**Lakefront
Utilities
Inc.**

**EB-2024-0038 - 2025 Incentive Rate Mechanism ('IRM') Application
Lakefront Utilities Inc. – Interrogatory Responses**

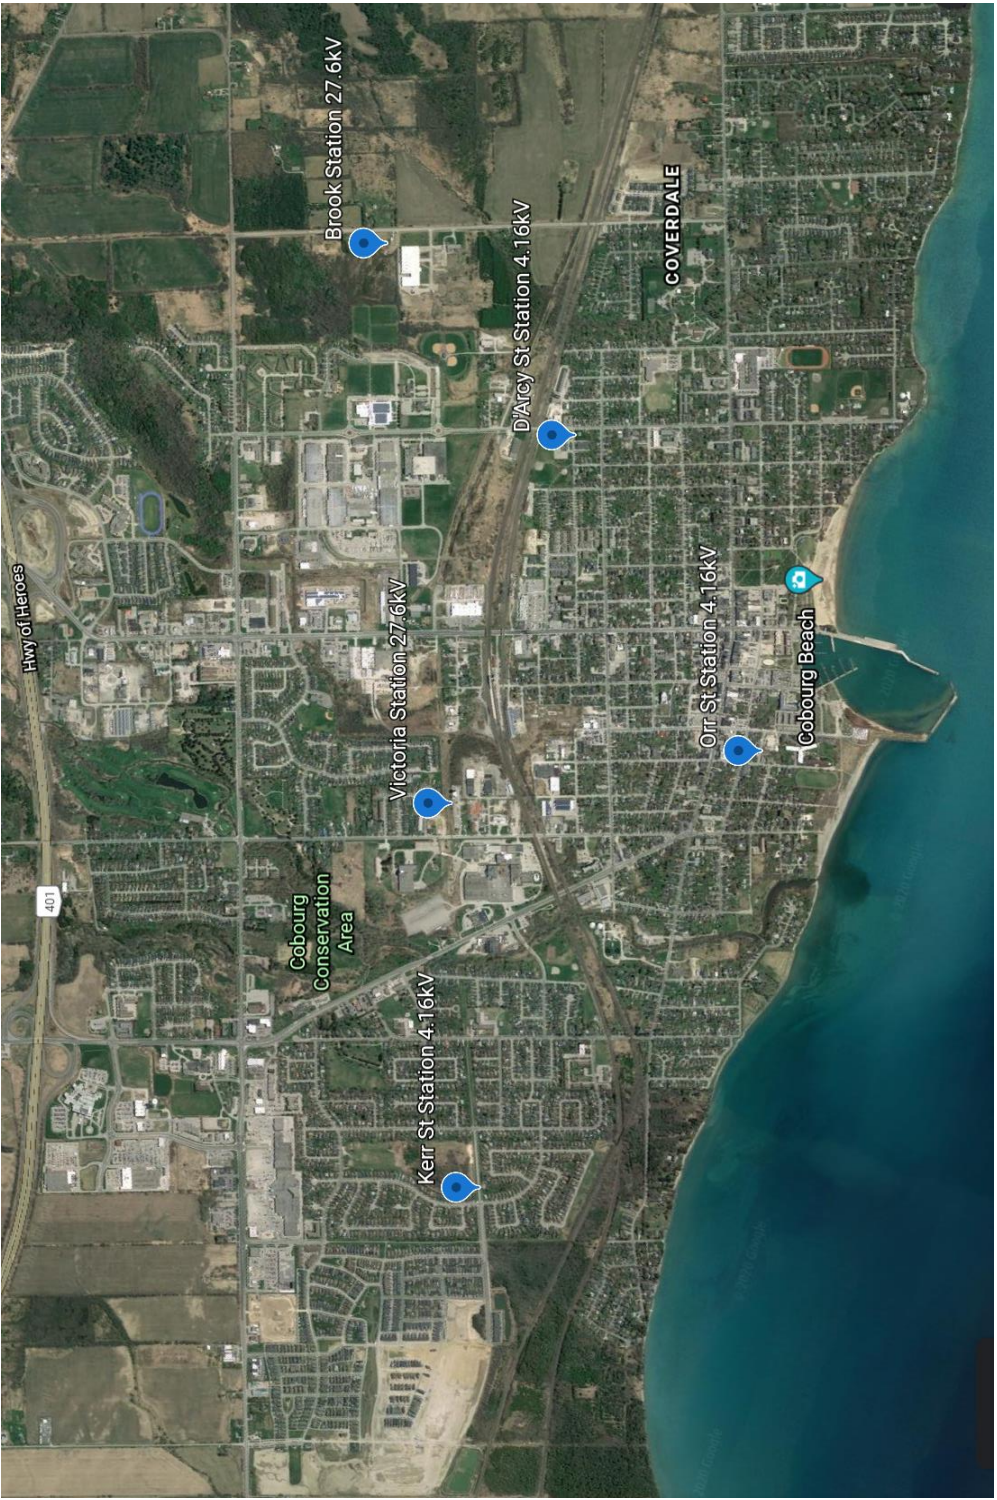
- b) Please provide the same information as part (a) at the end of 2023, after the construction of MS28-3.

Following the completion of MS28-3, there are 3 new 27.6 kV feeders available for utilization, each having approximately 10 MVA of capacity. Approximately one half the customers on the existing F1 and F2 feeders were transferred to 2 new feeders from MS28-3. One of the new feeders from MS28-3 is for future use.

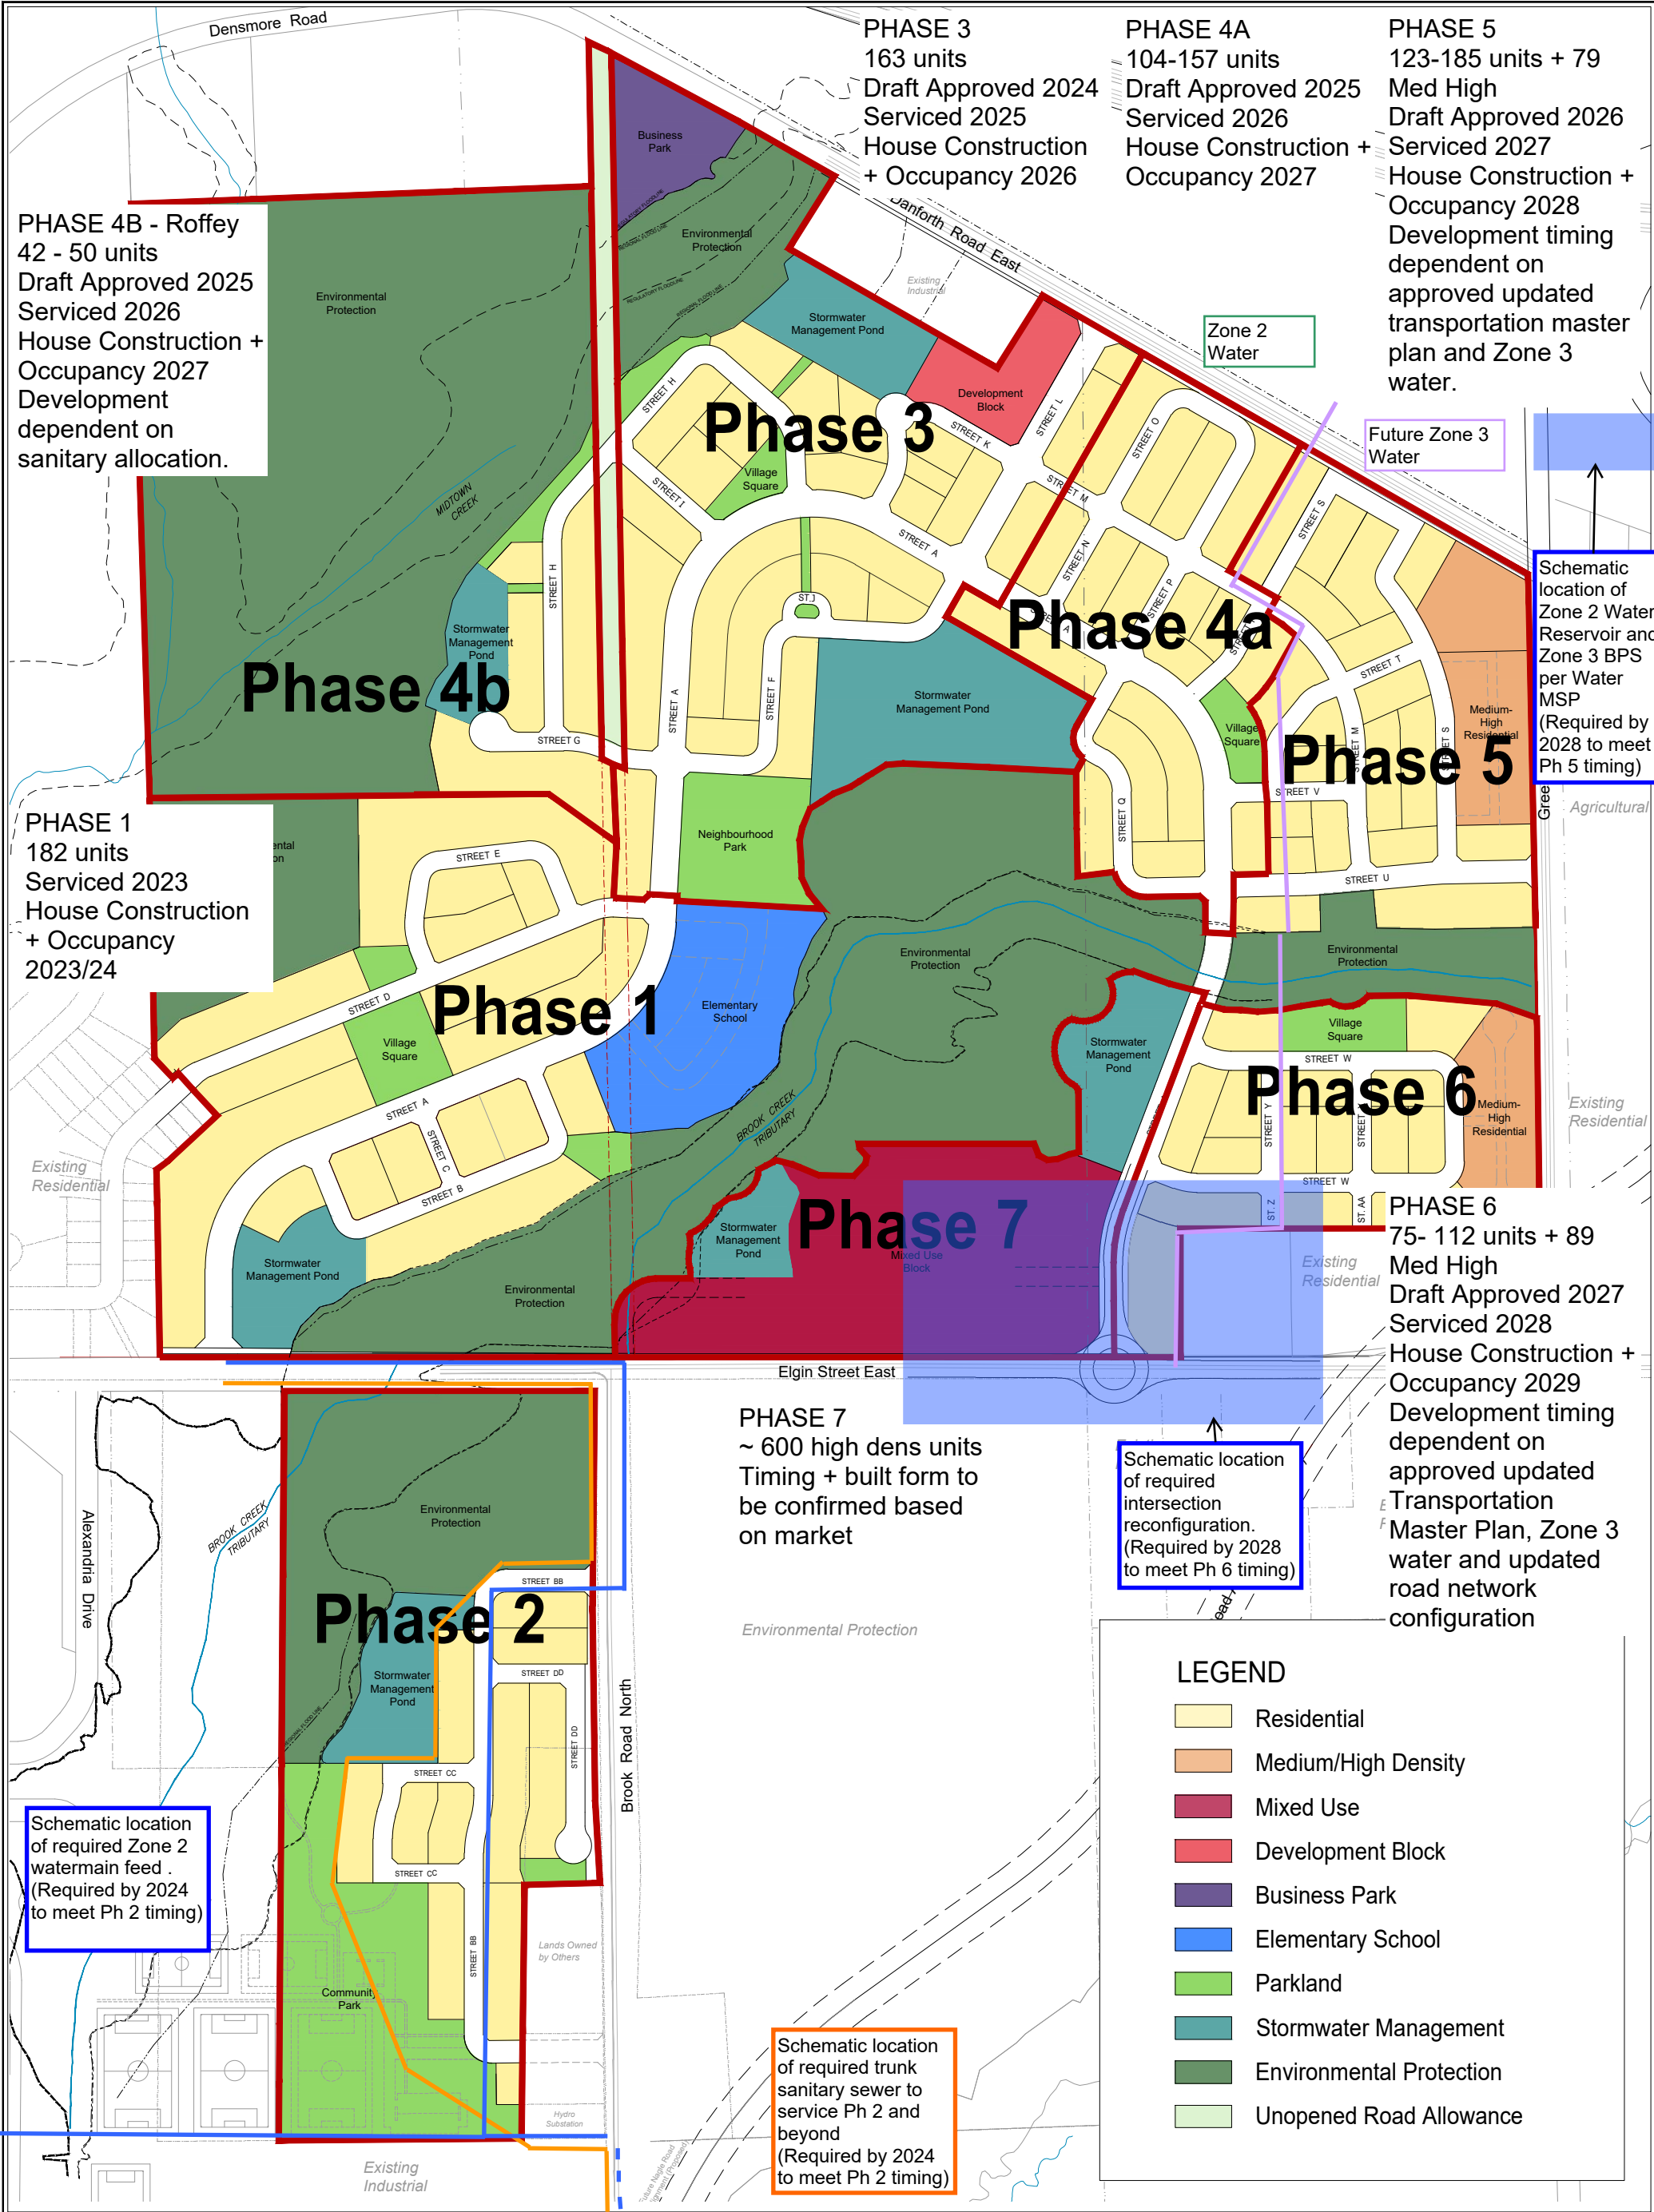
- iv. For each of the items above, indicate what station they would be connected to.

See Staff-4 b) iii) response.
